Gerry Essenberg
Clutha District Council
1 Rosebank Terrace
Balclutha, 9230

6-CO082.00

Mt Cooee Landfill Development Plan – Sheet Pile Cut-off Wall Review Report (Final Issue)

Figure 1: Typical bond construction detail (Courtesy of Royds Consulting, 1995)

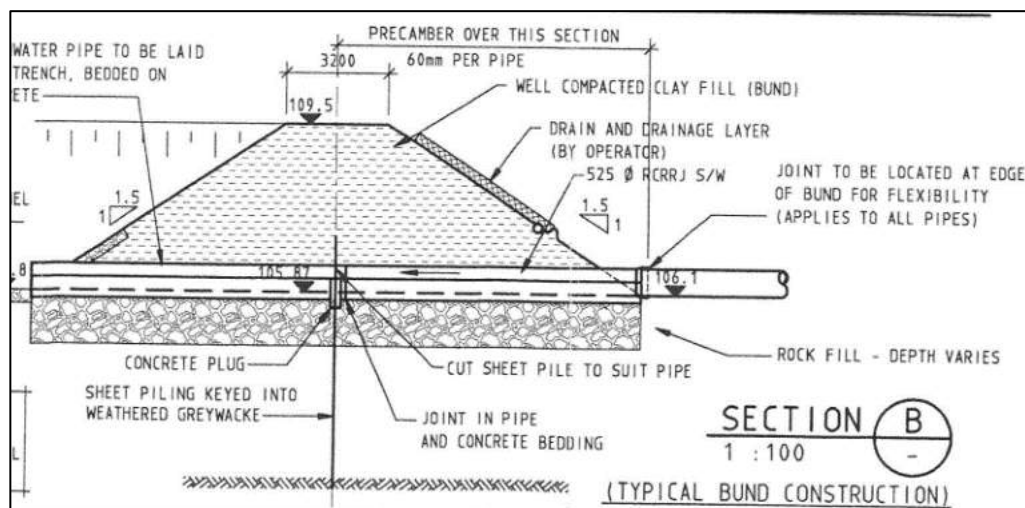
- The records by Royds Consulting Limited suggest two machine boreholes (BH1 and BH2) and two Scala penetrometer tests were carried out close to the location of the wall. The wall refusal depths corresponded well against the bedrock depths encountered within the boreholes, though was found to be deeper compared to the refusal depths of the Scala penetrometer tests. A typical cross section of the bund and the cut off wall is presented in Figure 1 below.

Figure 2: Schematic elevation of cut off wall (image courtesy of Royds Consulting 1995)

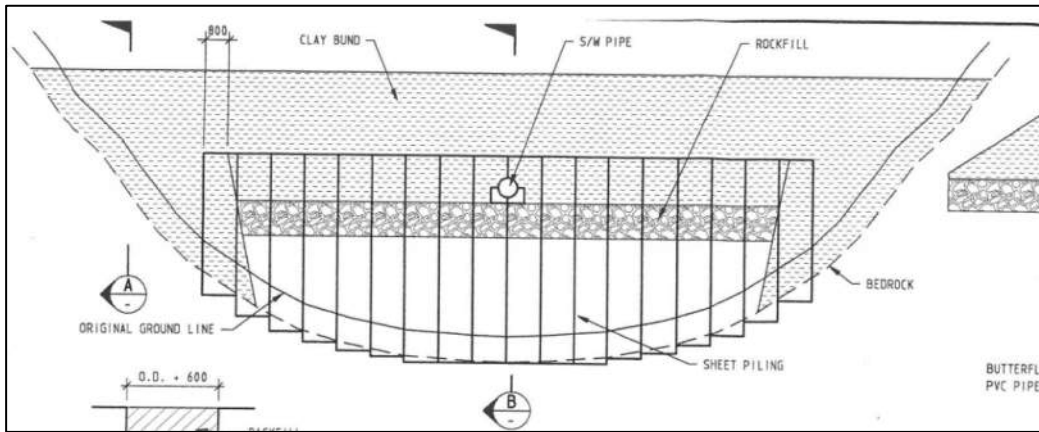
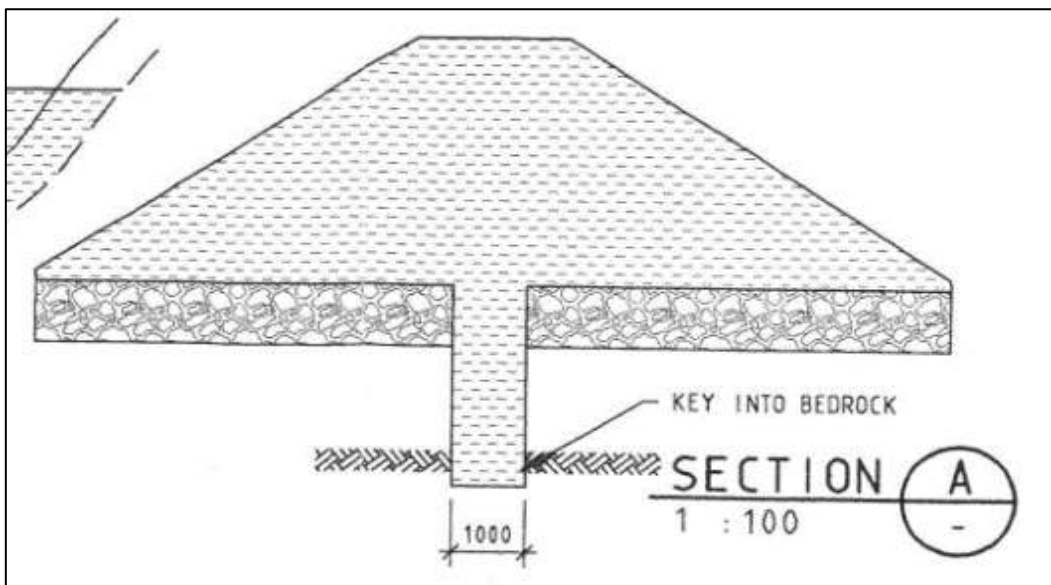
- The historic drawings indicate the top of the cut off wall is likely in the order of 2m to 3m below the crest of the clay bund. A rock fill layer has been constructed within the footprint of the clay bund and behind the sheet pile wall, though its thickness has not been recorded on the drawings.
- A historic drawing with a schematic elevation of the cut off wall suggests the sheet pile wall is situated along the central section of the clay bund, where the bedrock is deepest at the valley floor (in the order of 10m or so). Instead of the sheet pile wall, it appears that an approximately 1.0m wide low permeability clay barrier was constructed along the clay bund beyond the two ends of the sheet pile wall, where bedrock becomes progressively shallower. An extract from the drawing is presented as Figures 2 and 3 below.
